# St Marys Intermodal Modification 3

Inclusion of a construction stockpile site, revised development layout and additional land.

State Significant Development Modification Assessment  
(SSD 7308 MOD 3)

**Figure 6** | Revised development boundary within red dotted line (Source: Applicant's modification report)

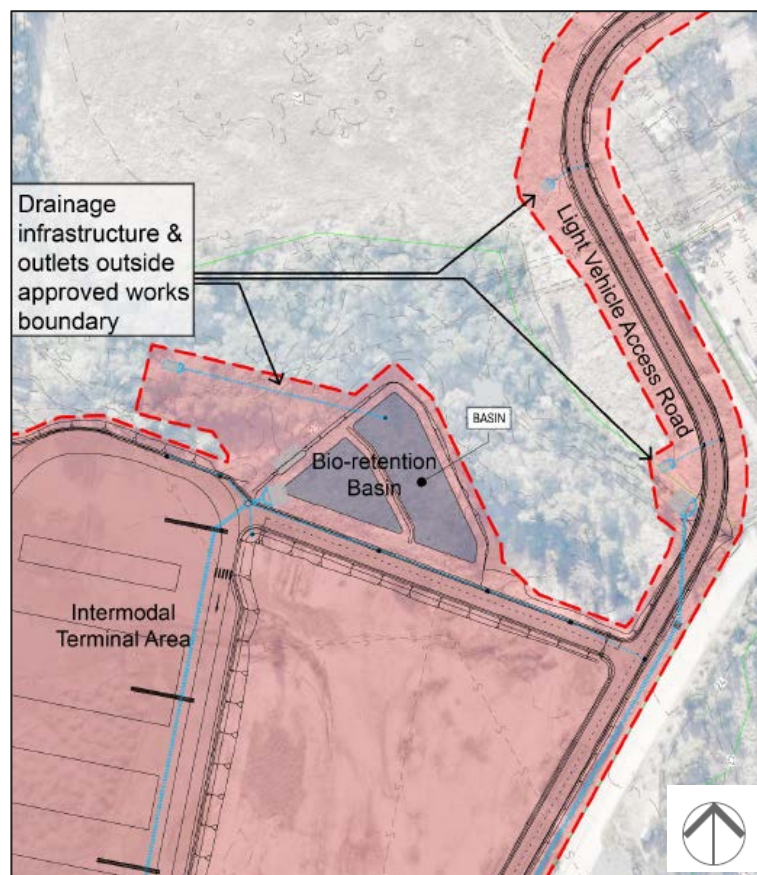
The proposal seeks to amend the development layout at Appendix 1 of the development consent to accommodate changes to drainage infrastructure and outlet design for the site. The proposed changes are outlined in **Figure 6** and **Figure 7** and include the following:

- extending the development layout to the immediate west of the bio-retention basin (to the north of the intermodal terminal area, within the Little Creek Riparian area) (**Figure 6**)
- widening of the Lee Holm Road light vehicle access road (**Figure 6**)
- widening of the works area either side of the Forrester Road heavy vehicle access road (**Figure 7**).

The Applicant submits that the proposed drainage works encroach outside the approved development layout boundary at Appendix 1 of the development consent. The proposed drainage works would require the removal of additional native vegetation within the Little Creek Riparian area (to the immediate west of the bio-retention basin), along the Lee Holm Road light vehicle access road and also along the Forrester Road heavy vehicle access road.

As part of their submission on the modification report, Council raised concerns in regard to the amended development layout and drainage infrastructure proposed. In particular, Council stated that the revised development layout would represent an incursion into the Little Creek Riparian area and recommended that the Applicant investigate alternatives to the spatial arrangement of drainage infrastructure to avoid impacts to biodiversity.

The Department has carefully considered Council's concerns regarding biodiversity impacts to the Little Creek Riparian area and has recommended a condition requiring the Applicant to update the Vegetation Management Plan under condition B33(g), to consider the scope of impact to the Little Creek Riparian area as a result of the modification.

**Figure 8** | Sydney Water approved connection point (Source: Applicant's modification report)

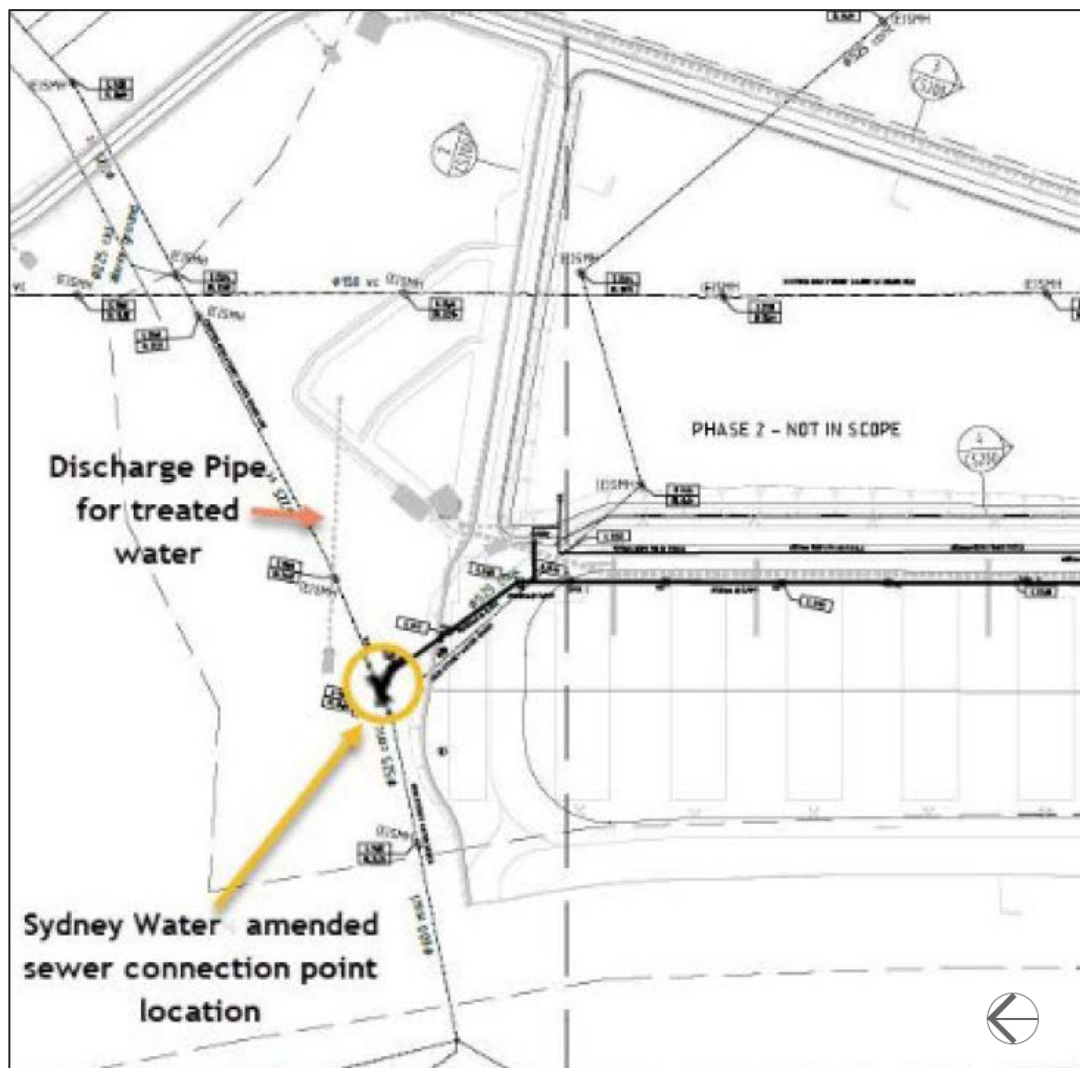
As part of the RtS, the Applicant advised that changes made to drainage infrastructure connections within the Little Creek Riparian area are a result of:

- Sydney Water changing the approved connection point into the Little Creek Riparian area (**Figure 8**)
- a discharge pipe for treated water (extending from the bio-retention basin to Little Creek) is required to dispose of filtered water from the bio-retention basin and to comply with water quality objectives for the project.

The Applicant asserts that the work area footprint for the proposed drainage infrastructure has been reduced to the smallest practical size, based on findings from design and construction reviews undertaken by the construction contractor for the project. The Applicant considered that design, constructability and safety considerations have been optimised to mitigate impacts to the Little Creek Riparian area, as far as practical.

**Figure 9** | Proposed revised development layout (Source: Applicant's modification report)

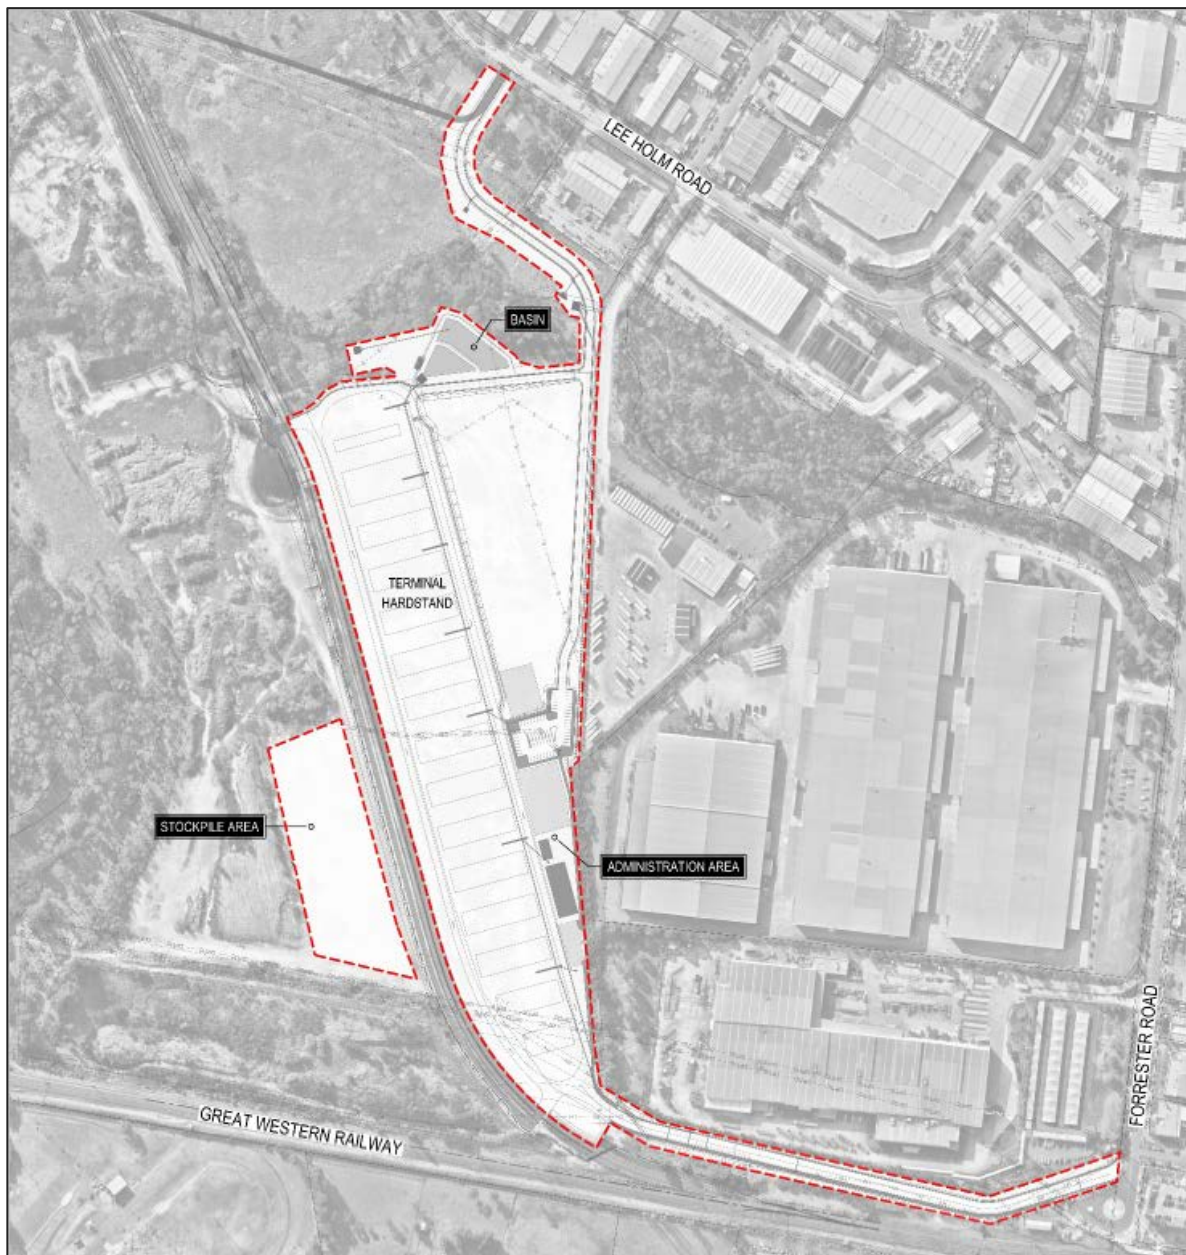
The Department has reviewed the proposed changes to the development layout for the purposes of revised drainage infrastructure and outlet design for the site, and considers the changes to be acceptable. The Department's consideration of the proposed stockpile site is detailed separately in **Sections 6.2** and **6.3**. Subject to the assessment undertaken at **Section 6.2**, the Department proposes to amend Appendix 1 of the development consent to include the revised development layout boundary as shown at **Figure 9**.

**Figure 10** | Proposed stockpile site (green shading) (Source: Applicant's modification report)

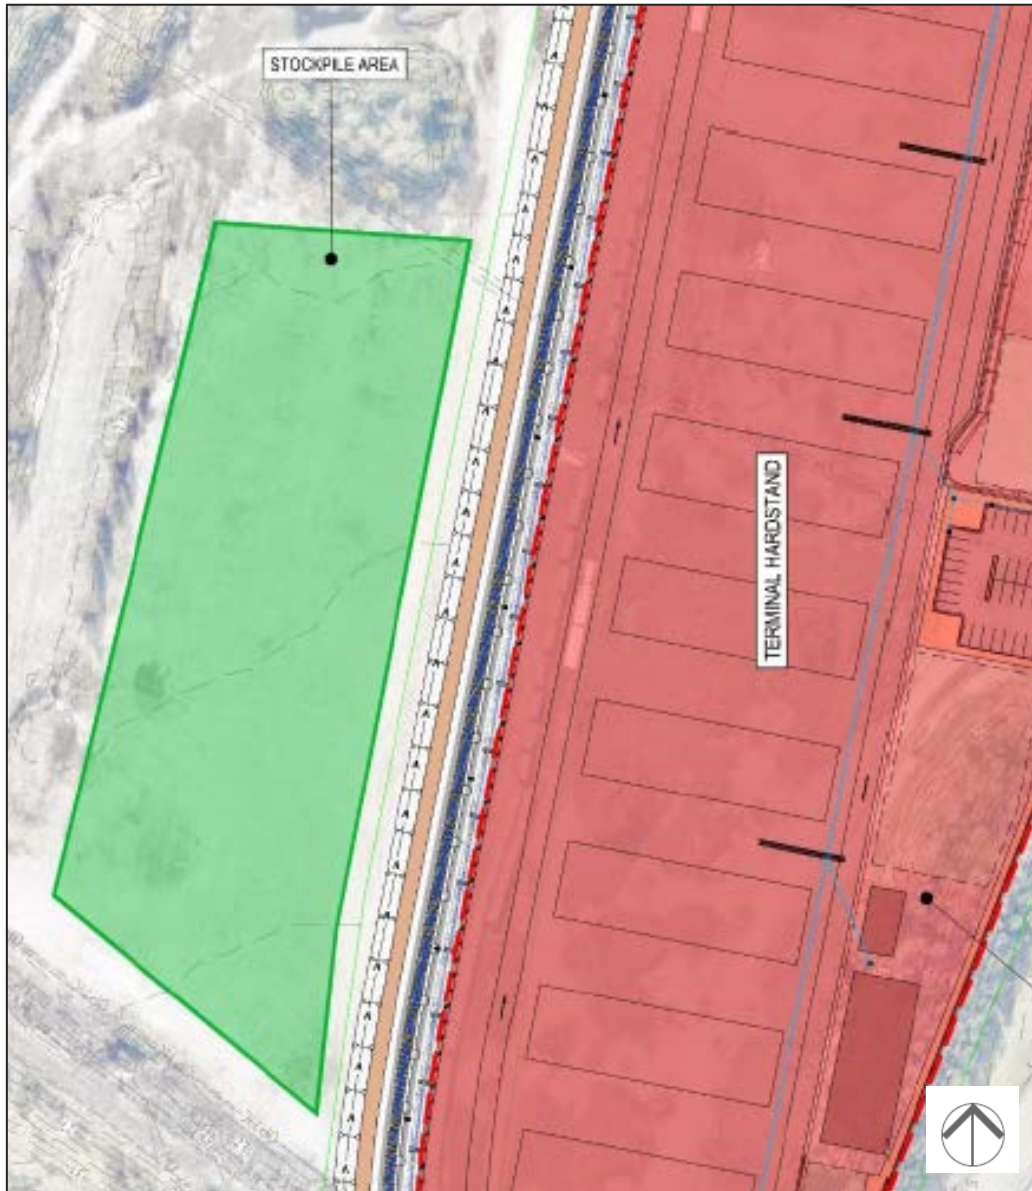
The proposal seeks to further amend the development layout at Appendix 1 to include use of a temporary excavated material stockpile site on Lot 2031 DP 815293. The inclusion of Lot 2031 DP 815293 as part of the site is considered in detail at **Section 6.3**. The excavated material stockpile site is proposed to be located on a cleared section of Lot 2031 DP 815293, to the immediate west of the existing rail spur (**Figure 10**).

Notwithstanding, as part of its submission on the modification application, Council recommended that the Vegetation Management Plan (VMP) required under condition B33(g) be expanded to include the scope of works proposed on lot 2031 DP 815293. In particular, Council recommended that the stockpile site be rehabilitated to 'natural vegetation conditions', rather than 'pre-existing conditions' that are currently present on the exotic/cleared stockpile site. The Department acknowledges Council's concerns regarding appropriate rehabilitation of the stockpile site and supports the recommended updates to the VMP. Consequently, the Department recommends the Applicant be required to update the VMP to include measures to rehabilitate and revegetate the stockpile site after use.

Overall, the Department acknowledges that use of the temporary stockpile site is an integral and critical component of construction works for the development. To appropriately manage use of the temporary stockpile site during construction, the Department recommends the Applicant be required to update the development's Construction Soil and Water Management Sub Plan to consider the location of the stockpile site and proposed erosion and sediment control measures, as relevant.

To appropriately manage use of the temporary stockpile site during operation of the development, the Department recommends enforcement of a five year time-limit on use of the stockpile site (from establishment of the stockpile site). Further, the Department recommends a series of performance based conditions to manage use of the stockpile site during operation, including a requirement to shape, survey and hydroseed the stockpiles as required.
